TECHNICAL BULLETIN #32 June 29, 2007

TECHNICAL REFERENCE: 062907/32

MODEL/S AFFECTED: GB/5 and FB/80 models since the machine serial number 0500 - ALL PART/S DESCRIPTION: new 16 pin ribbon cable wing connector and push button bottom box

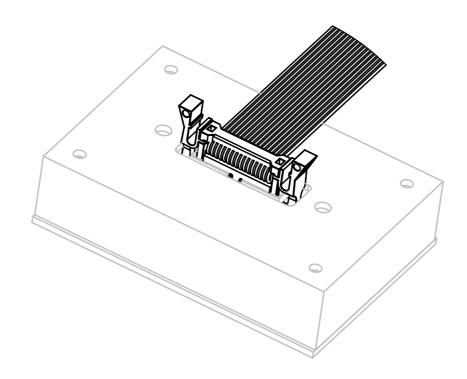
La Marzocco replaced the 16 pin ribbon cable connector with a new updated model.

The new connector is equipped with two wing clips on the sides to ensure the connection between the cable and the female connector.

Consequently the back plastic box cover (EE model-E.1.007) for the manual brew switch has been modified with a larger slot to accomodate the new connector.

The modification does not affect the rest of the GB/5 & FB/80 AV model key pad boxes.

New kit and actual version used on machines from s/n 0500 which will include the back box cover with a larger slot for the new connector size and the following new wing connector parts:
